OPERATOR'S MANUAL
FOR
NIGHT VISION SIGHT,
INDIVIDUAL SERVED WEAPON AN/PVS-2
(5855-087-2947), ANIPVS-2A
(5855-179-3708), AND ANIPVS-2B
(5855-760-3869)

CHANGE

NO 1

TM 11-5855-203-10, 29 August 1974, is changed as follows:

Figure 2-4.1 1. Installation of M60 adapter assembly (sheet (1) of 4).

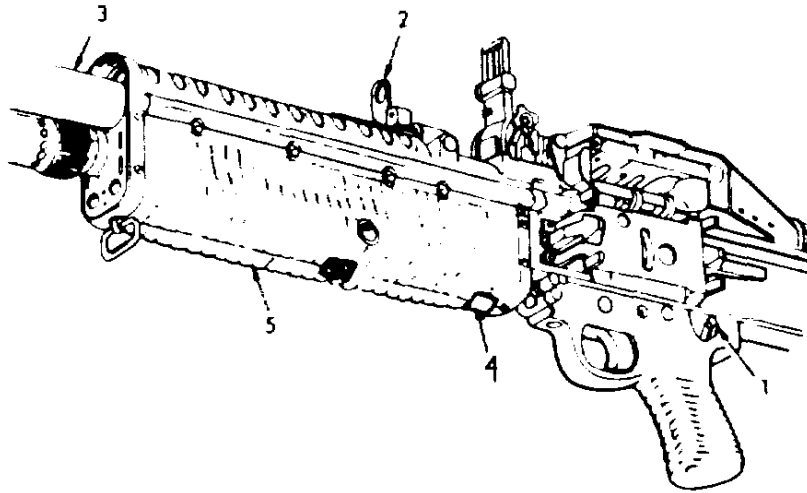
2-4.1. Installation on M60 Machine Gun

- a. Refer to figure 2-4.1 for installation of the M60 adapter assembly on the M60 machine gun

- b.* Rotate the lock knobs of the boresight mount assembly forward (toward objective lens) until they come to a stop on the pins on the assembly.
- c.* Slide the boresight mount assembly onto the guide rail of the M60 adapter assembly from the rear until it is positioned against the pin stop of the guide rail.
- d.* Lock the night vision sight on the M60 adapter assembly by rotating the two locking knobs of the boresight mount assembly in a rearward direction.

Figure 24.1 (2). Installation of M60 adapter assembly (sheet 2 of 4).

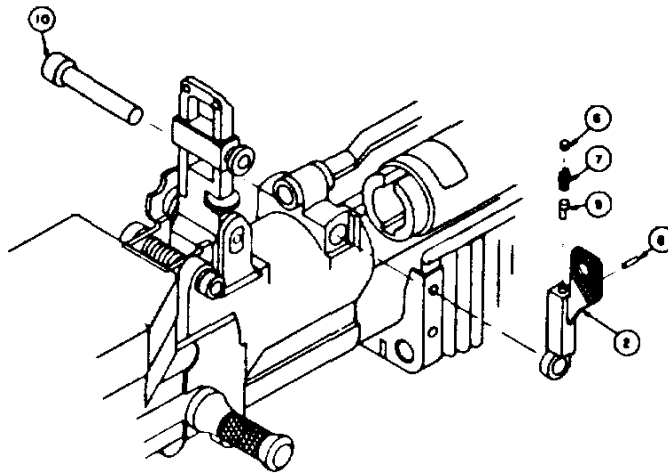
RELEASE LEVER AND SHAFT REMOVAL

THE DETENT PLUNGER (6) AND DETENT SPRING(7) ARE SPRING TENSION LOADED BEFORE REUOVING LOCK PIN (8) PLACE AND OVER TOP OF BARREL RELEASE LEVER (2) SO THAT PARTS WILL NOT BE LOST UPON REMOVAL OF LOCK PIN

REMOVE LOCK PIN (8) DETENT PLUNGER (6). DETENT SPRING (7) AND DETENT PIN (9) FROM BARREL RELEASE LEVER (2)

REMOVE BARREL RELEASE LEVER (2) AND WITHDRAW BRARREL LOCK SHAFT (10)

THE BARREL LOCK SHAFT (10) AND THE BARREL RELEASE LEVER (2) INCLUDING LOCK PIN (8). DETENT PLUNGER (6), DETENT SPRING (7), AND DETENT PIN (9) ARE REPLACED WITH A COMBINATION BARREL LOCK SHAFT AND RELEASE LEVER (15) THAT IS SUPPLIED WITH THE WEAPON ADAPTER BRACKET ASSEMBLY

Figure 2-4.1 (3). Installation of M60 adapter assembly (sheet 3 of 4).

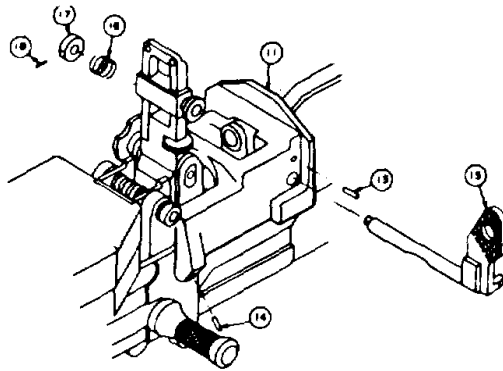
SADDLE BLOCK INSTALLATION

NOTE: BEFORE INSTALLING SADDLE BLOCK (11) ON GUN REMOVE ADAPTER BRACKET (12) LOOSEN FOUR SET SCREWS (13) AND (14) (TWO SET SCREWS ARE LOCATED ON EACH SIDE OF SADDLE BLOCK) AND REMOVE BARREL LOCK SHAFT (15) FROM SADDLE BLOCK

STEP 8 PLACE SADDLE BLOCK (11) DOWN INTO POSITION ON GUN

STEP 9 INSTALL BARREL LOCK SHAFT (15) INTO SADDLE BLOCK PLACE COMPRESSION SPRING (16) WITH RETAINING COLLAR (17) OVER END OF SHAFT AND INSTALL SPRING PIN (18) THROUGH COLLAR AND SHAFT. PUT RELEASE LEVER END OF BARREL LOCK (15) IN VERTICAL POSITION TO RECEIVE BARREL

STEP 12 SNUG UP EVENLY BY ALTERNATE GRADUAL TIGHTENING THE TWO SET SCREWS (13). DURING THIS PROCEDURE CHECK FREE MOVEMENT OF BARREL LOCK SHAFT BY RAISING AND LOWERING BARREL RELEASE LEVER TO INSURE THAT SHAFT IS NOT BINDING. THEN SNUG UP EVENLY IN SIMLAR MANNER THE REMAINING TWO SET SCREWS (14)

Figure 2-4.1 (4). Installation of M6O adapter assembly (sheet 4 of 4).

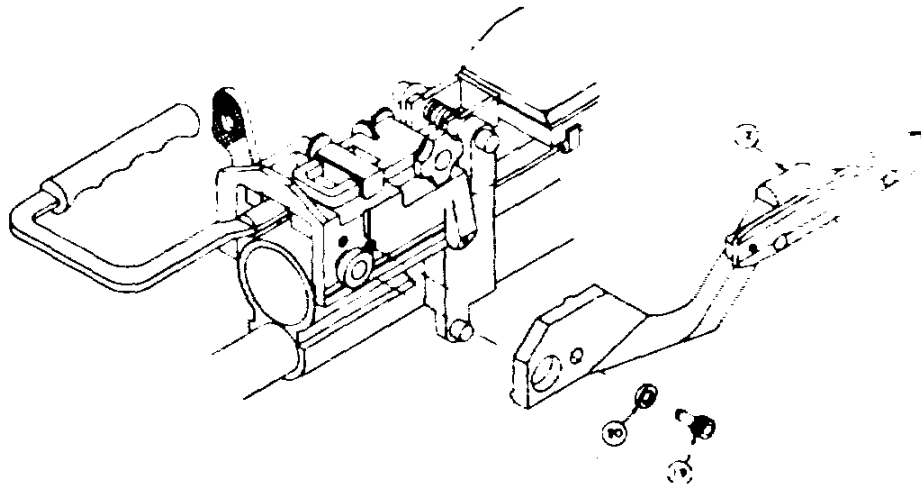
WEAPON ADAPTER BRACKET INSTALATION

- STEP 14 PLACE WEAPON ADAPTER BRACKET (12) IN PLACE AGAINST SADDLE BLOCK (11) AND TIGHTEN SCREW (19) THROUGH BLOCK WASHER (20) AND ADAPTER BRACKET INTO SADDLE BLOCK
- STEP 15 REPLACE HEAT SHEILD ON GUN BY GUIDING THE ASSEMBLY OVER THE OPERATING ROD TUBE TO INSURE THAT THE OPERATING ROD DOES NOT STRIKE THE BAFFLES INSIDE THE ASSEMBLY. ALINE THE RECESS IN THE HEAT SHIELD ASSEMBLY WITH THE END OF THE OPERATING ROD TUBE. TAP BOTTOM REAR OF THE ASSEMBLY FIRMLY WITH THE PALM OF THE HAND TO LOCK IT IN POSITON.
- STEP 16 REPLACE BARREL ON GUN FOLLOWING PROCEDURE GIVEN IN STEP 10 AND 11.
